# SERVICETEKNOTES

## TABLE OF CONTENTS

Figure 1

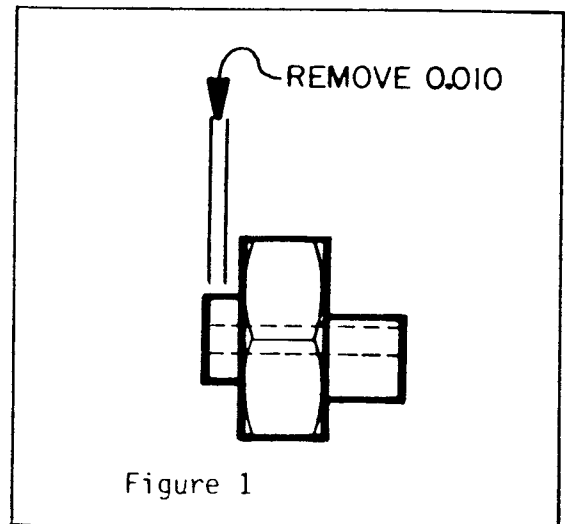
Problems with tightening the handle latch have been reported.

The problems are caused by close tolerances for thickness for the adjusting cam's (401-0243-00) centered extrusion (the short one) and the chassis sides.

When this problem is encountered, the best remedy is to file the short extrusion on the adjusting cam until it no longer extends through the chassis side. Remove approximately 0.010

inches (see figure 1) so that the extrusion is about 0.1 inches after filing. This will keep the cam from binding.

1750 PHASE SHIFTER, PARTS REMOVED

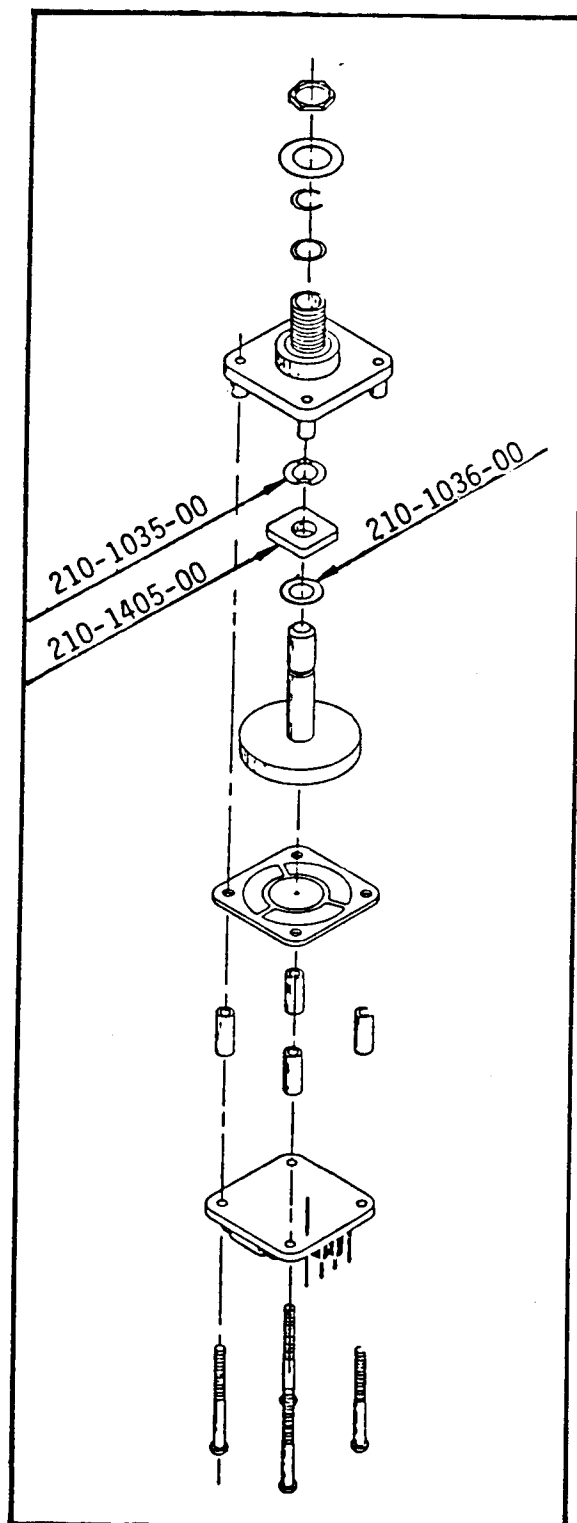
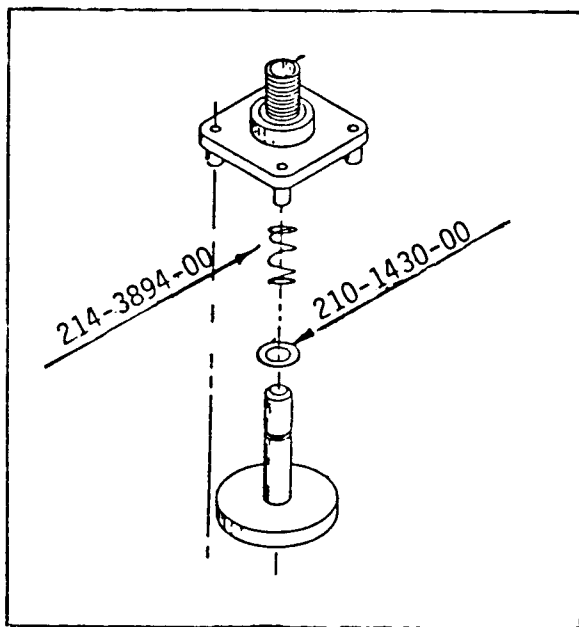
Mod 59447 has been implemented to improve the operation of 1750 Series Phase Shifter assemblies.

Early assemblies have exhibited problems of intermittent operation, due to difficulties associated with the spacing tolerances in the rotor/stator area. These tolerance problems appear as unstable vector displacement and extreme sensitivity to adjustment.

Mod 59447 removes three washers, and replaces them with one washer and one spring.

Parts Removed	Parts Added
210-1405-00	210-1430-00
210-1035-00	214-3894-00
210-1036-00

See the attached diagrams for details.
